BEXLEY POLICE FACILITY

**Re: Storm Water Inspection at Bexley Police Facility / Franklin County
Permit #: 4GC02912*AG**

Figure 1: Failed silt fence

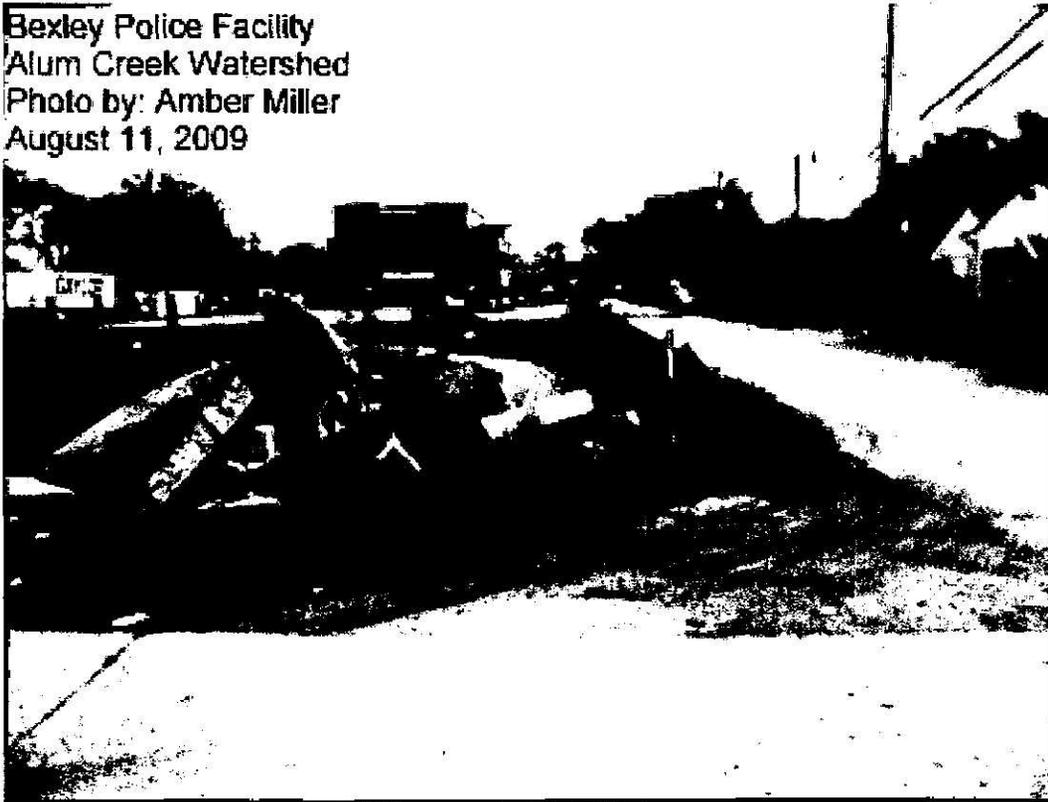
- The silt fence on the southwest portion of the site has failed and will require maintenance at this time (See Figure 1).
- Be aware the General Permit states that all barren areas which remain idle in excess of 21 days must be protected from erosion within seven days of the last earth disturbing activities. In addition, erosion protection must be implemented for all areas of final grade within seven (7) days.
